Submissions Report

Summerville Solar Farm

AE1235

Figure 3.1 Change in development footprint

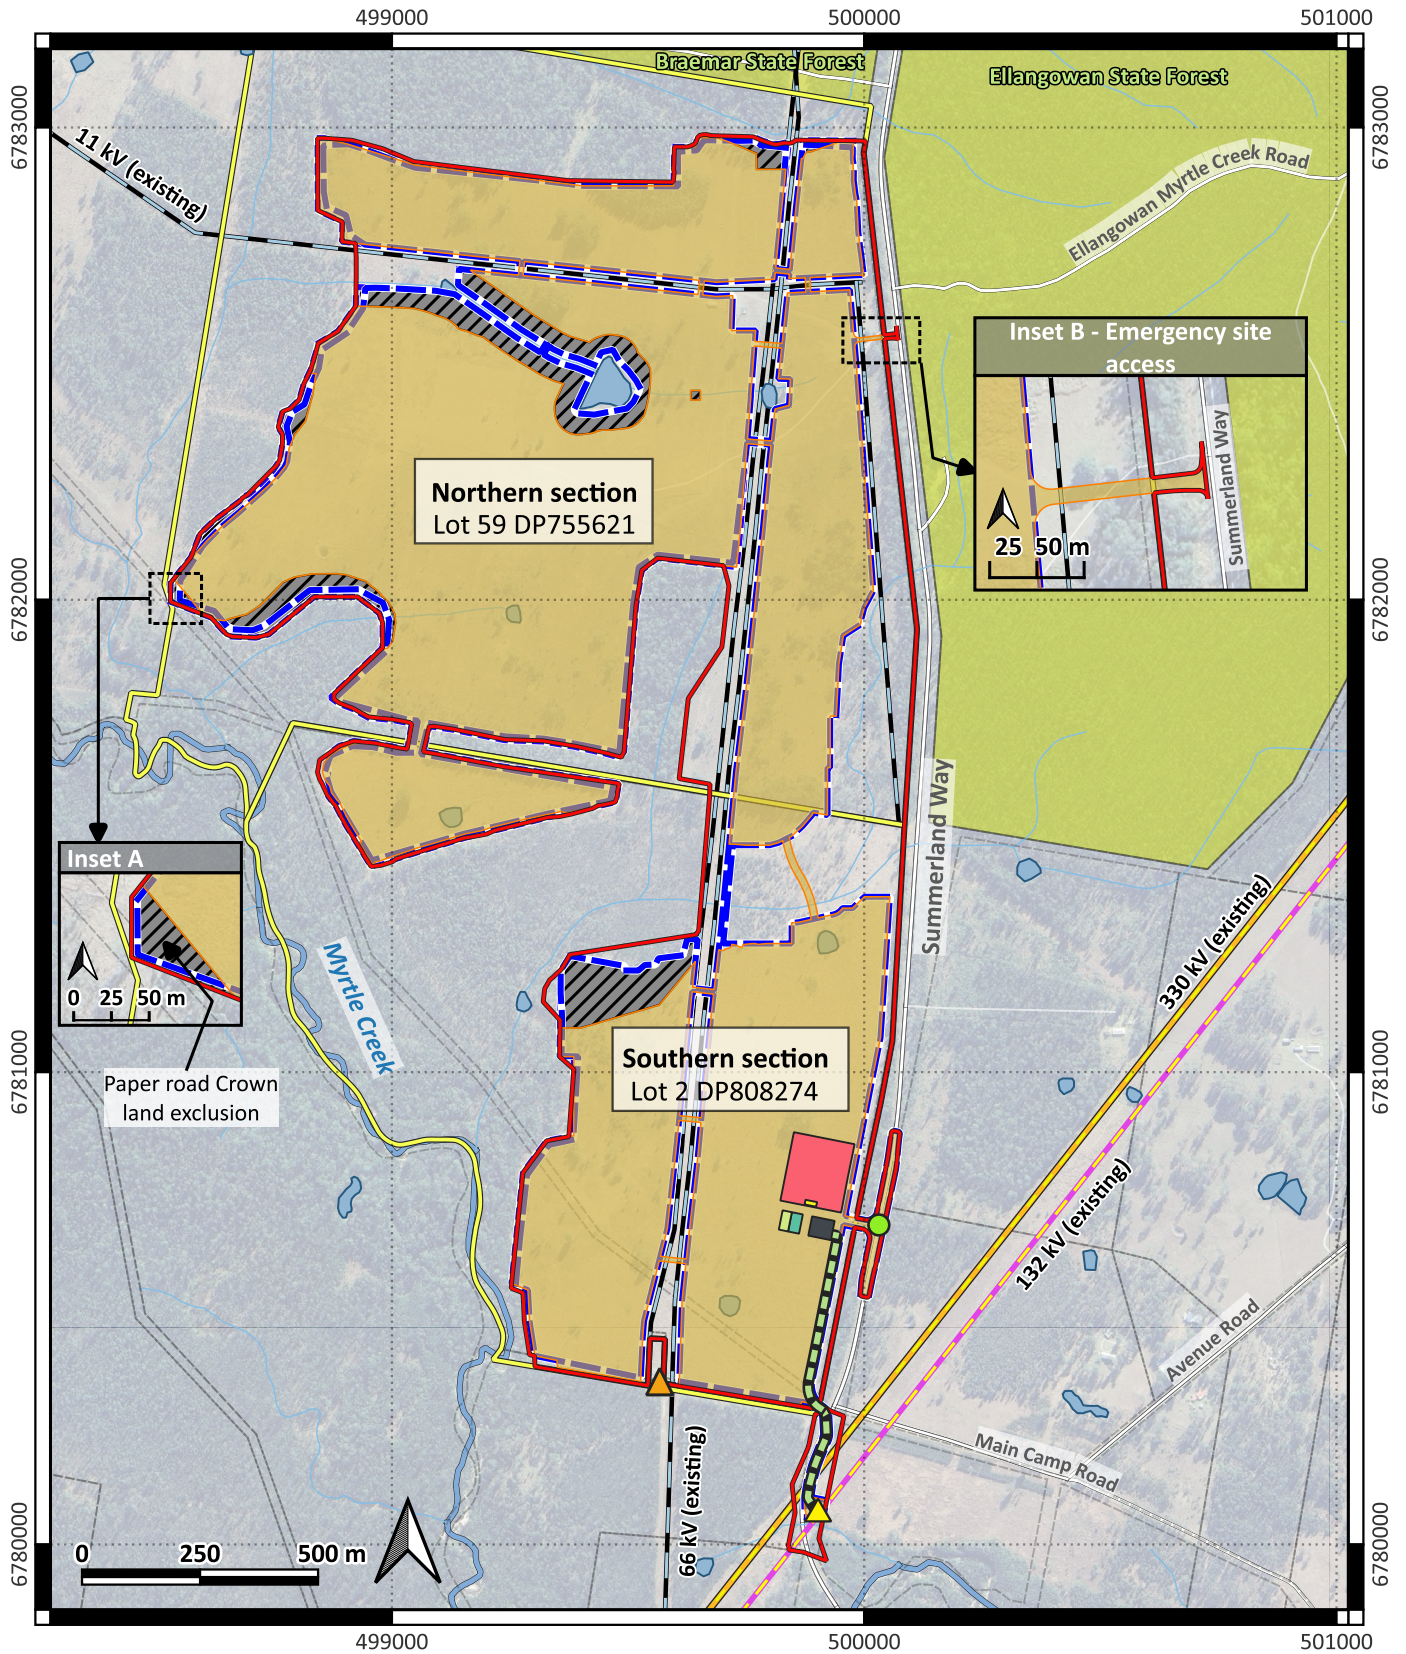
| Element | EIS phase (original) | Proposed |
|---|--|---|
| Development footprint | Approximately 196 ha | Approximately 183 ha The revised development footprint is shown in Figure 3.1, below. The net reduction in area due to a combination of: <ul style="list-style-type: none"> refinements to avoid biodiversity (predominant reason for overall footprint reduction) (see Section 4.1.4) inclusion of emergency access as part of development footprint and project area (very minor addition of area) avoidance of interaction with the crown paper road along the western side of the northern parcel (very minor reduction in area). |

Figure 4.1 BESS layout showing dimensions

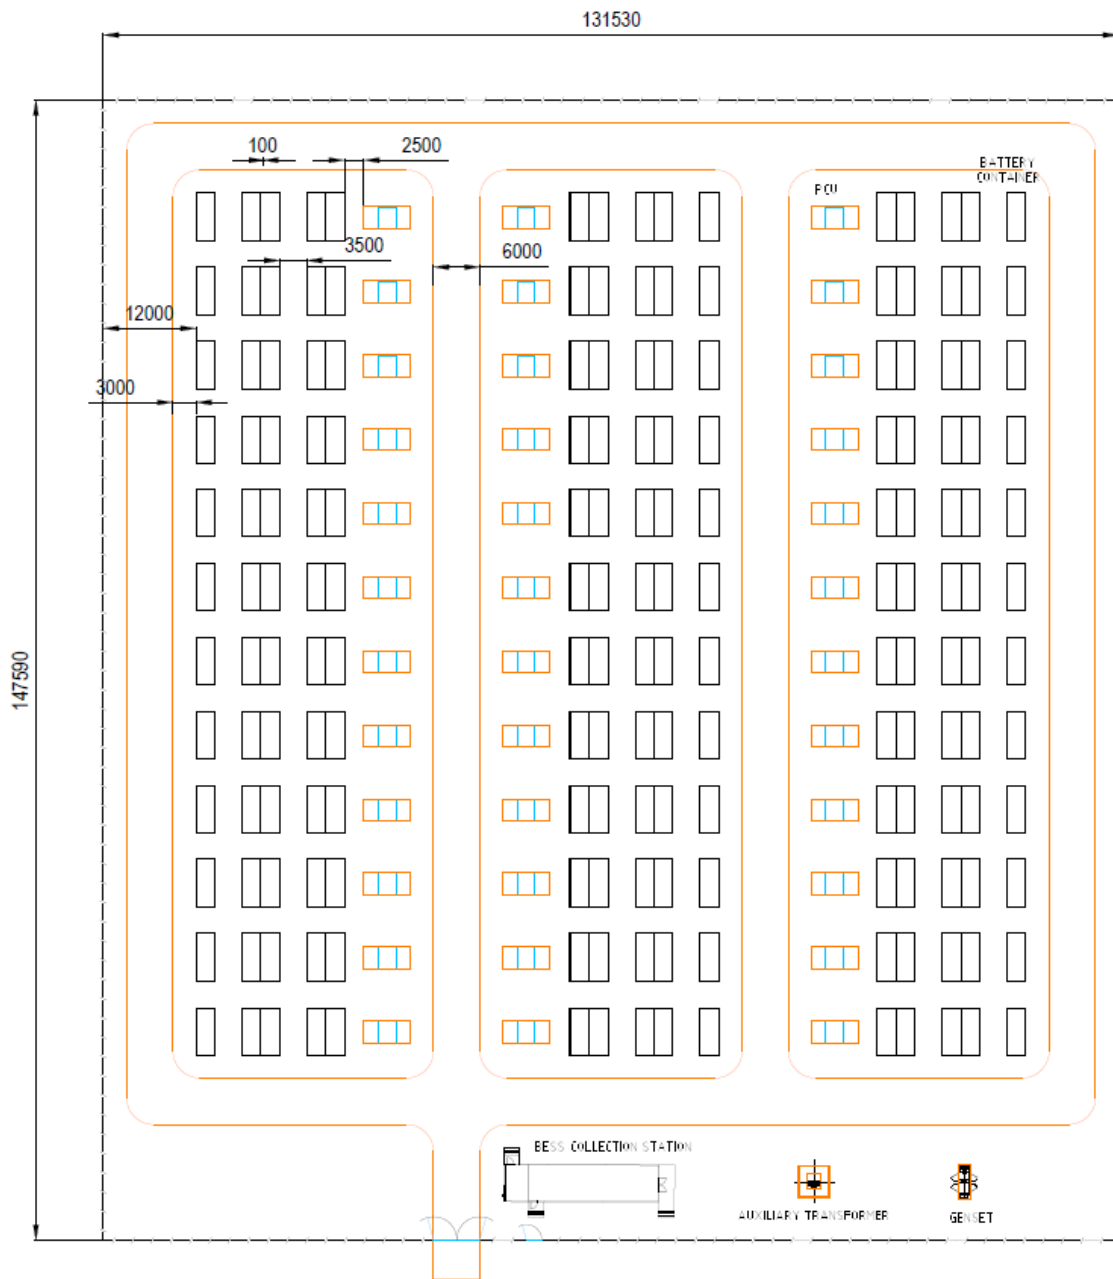
| ID | Aspect | Detail of submission | OX2 response | Additional mitigation measures |
|-----------|---------|--|---|--------------------------------|
| | | Confirmation 1.9 hectares allocated to the BESS is sufficient with consideration of the separations between batteries and equipment within the area. | <ul style="list-style-type: none"> OX2/Accent have provided Mendham Consultants with a layout (including BESS /inverter/transformer dimensions and separation distances) to confirm that the required separation distances are met or exceeded, and that BESS facility fits within area available (see Figure 4.1, below). | - |
| | | Please provide the dimensions of the layout in Figure 3.1 of the EIS and determine the area requirements for a group of batteries. | <ul style="list-style-type: none"> Refer Items 2 and 3 (above). | - |

Figure 4.1 Strahler stream order and the development footprint

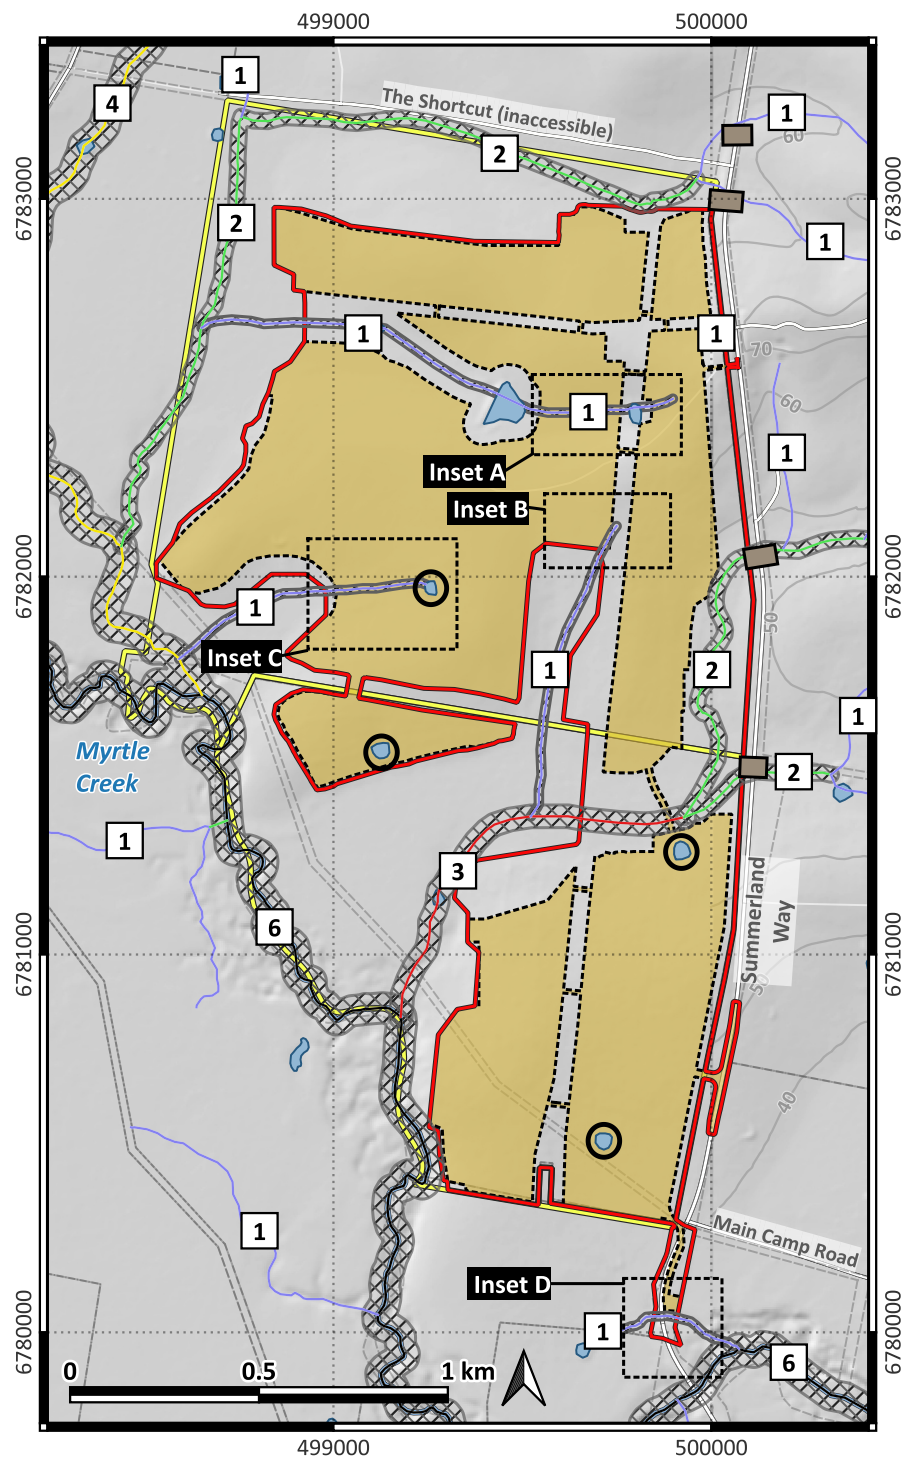
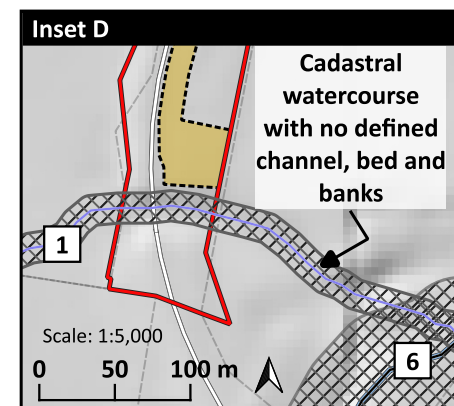
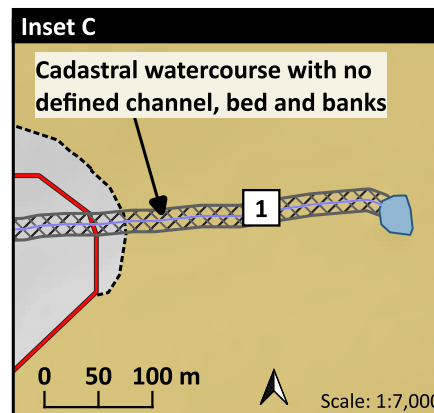
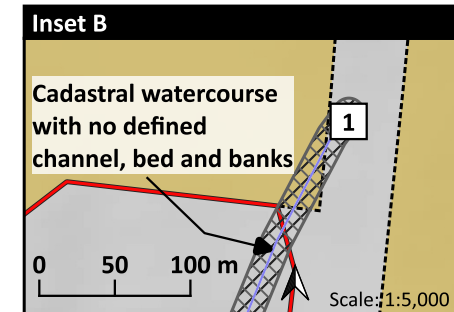
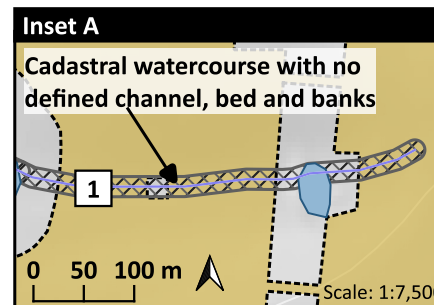
| ID | Aspect | Detail of submission | OX2 response | Additional mitigation measures |
|----|-----------------|---|--|--|
| | Waterfront Land | Waterfront Land Recommendation - pre-determination The proponent should clarify the proposed infrastructure layout to meet the buffer requirements from watercourses as defined in the Guidelines for Controlled Activities on Waterfront Land. | <ul style="list-style-type: none"> Figure 4.2, below, shows the waterway classifications within the project area and associated riparian corridors (buffers). Figure 4.2 shows that watercourse buffer requirements have been allowed for in the development footprint (both the footprint presented in the EIS and the current revised footprint) in accordance with the <i>Guidelines for Controlled Activities on Waterfront Land</i>. | - |

Figure 1: *Dendrobium melaleucaphilum* species polygon

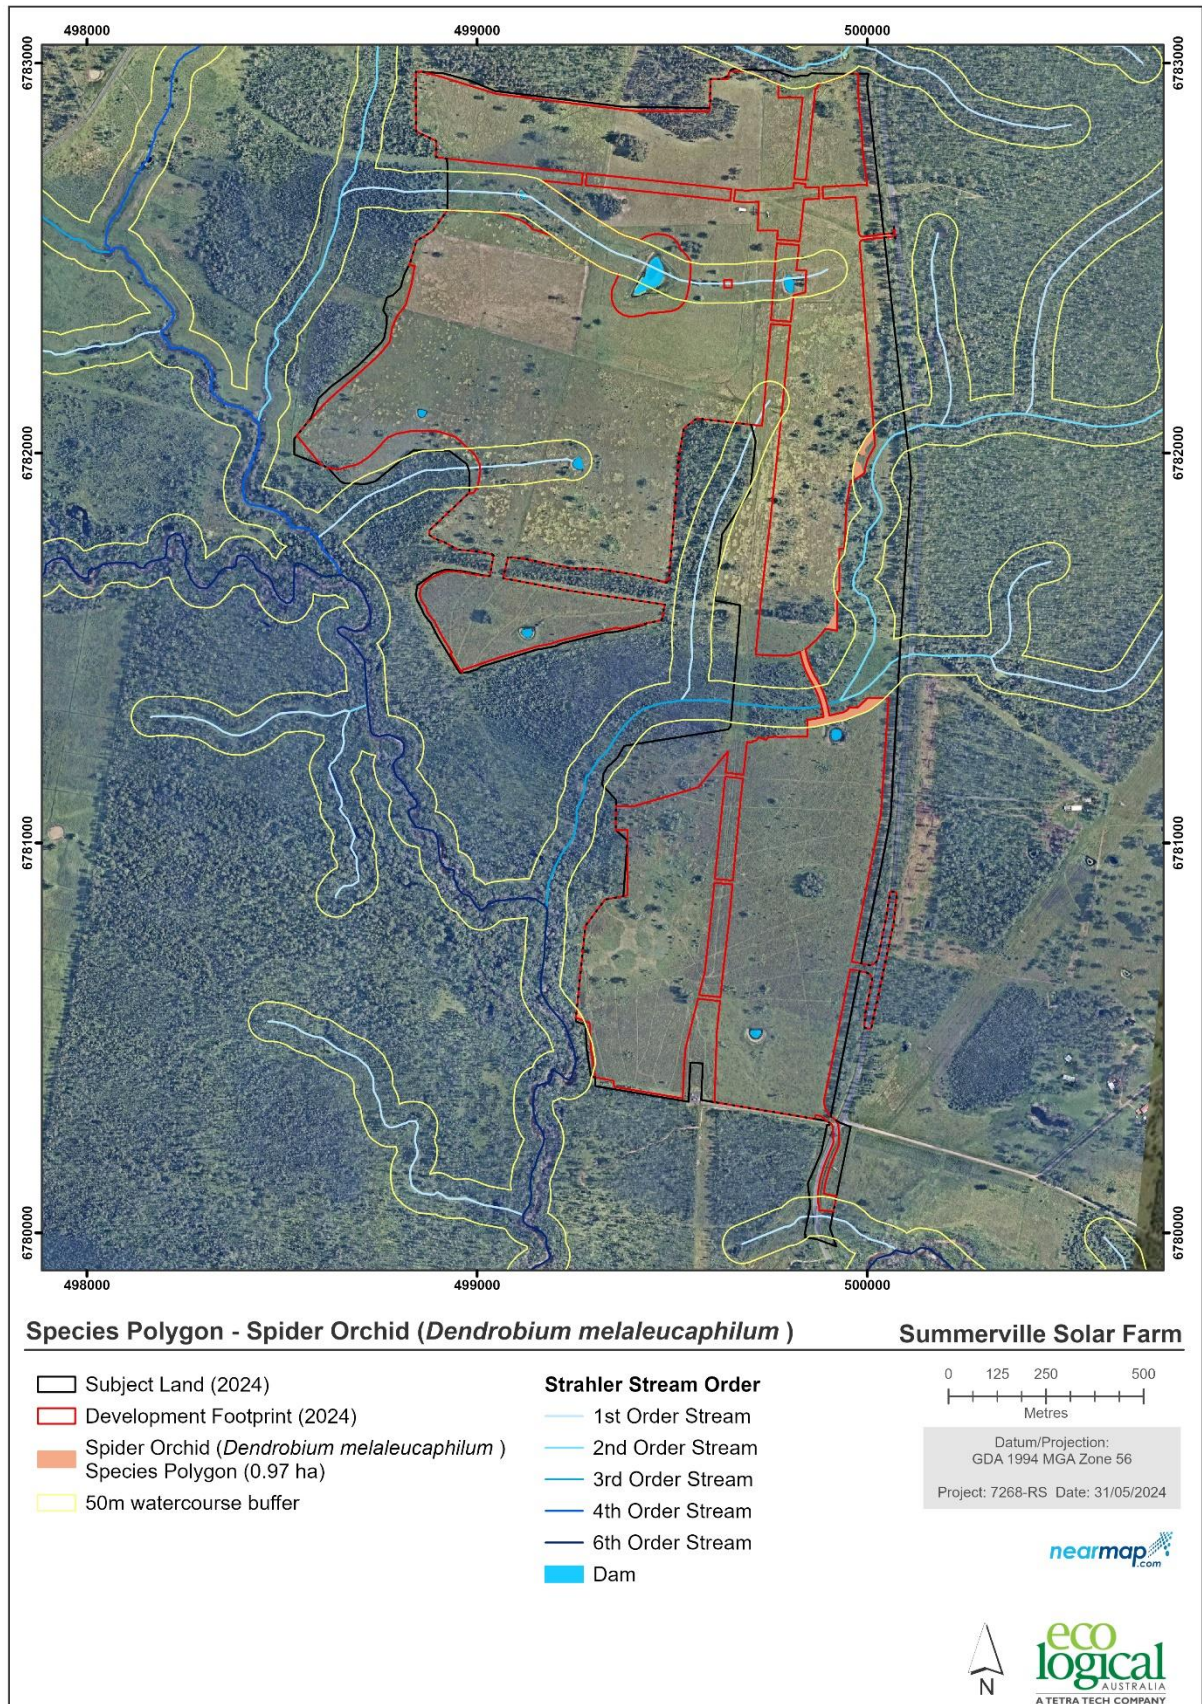
Based on the above, it is unlikely an amended BDAR would be required post targeted surveys, however, a precautionary approach has been adopted and a species polygon has been developed (Figure 1). This is based on potential suitable habitat within the Development Footprint 2024. The total area of the species polygon for *Dendrobium melaleucaphilum* is 0.97 ha. This has been calculated within the BAM-C as requiring a total of 18 credits. These credits will only be required should *Dendrobium melaleucaphilum* individuals be identified.
